N5106A-03

S E R V I C E N O T E

N5106A (PXB) Baseband Generator and Channel Emulator

The A11 System Clock board, (N5105-60006) has under rated components increasing the potential for early failure.

FRONT SIDE MOD LOCATIONS

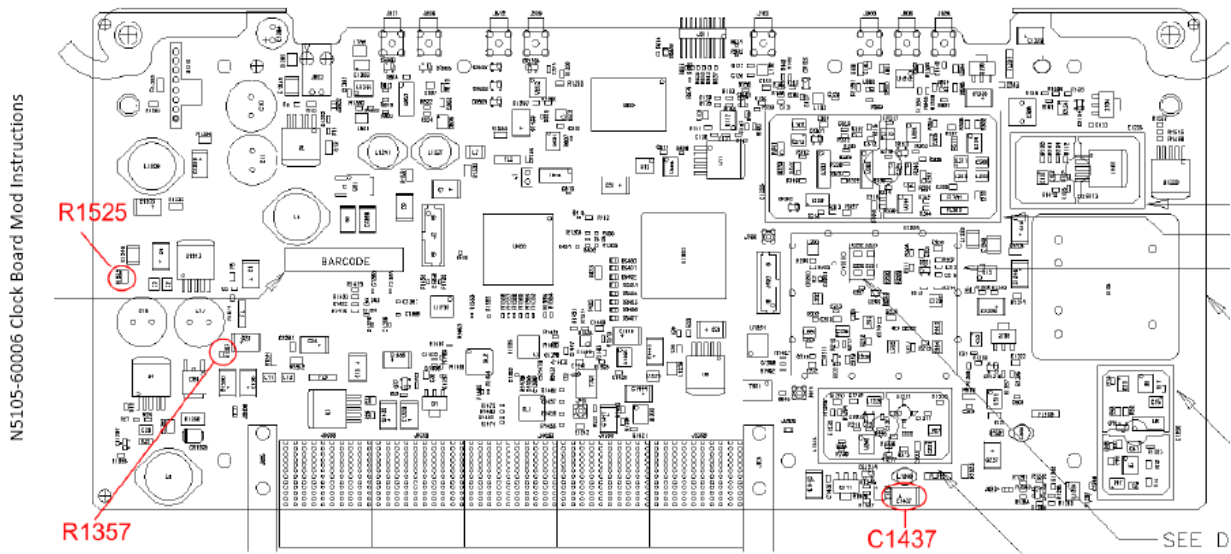
All PXBs of the suspect serial number range need to have their system clock boards checked at next service and replaced if they have the early revision board without modifications. The suspect boards can be identified by the revision code under the left extractor, any board with Rev 003 or before need to be checked to determine if the board has been reworked (see below). If the system clock board has not been reworked replace it with new board from SPO.

R1357 before modification

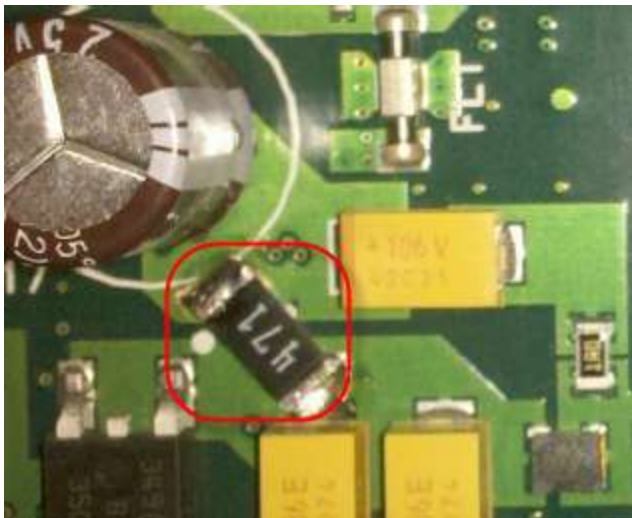
To determine if you have a modified board look at R1357 and R1525 and verify that the original resistors have been replaced with larger resistors (see photos below). If the modifications have been made do not replace board.
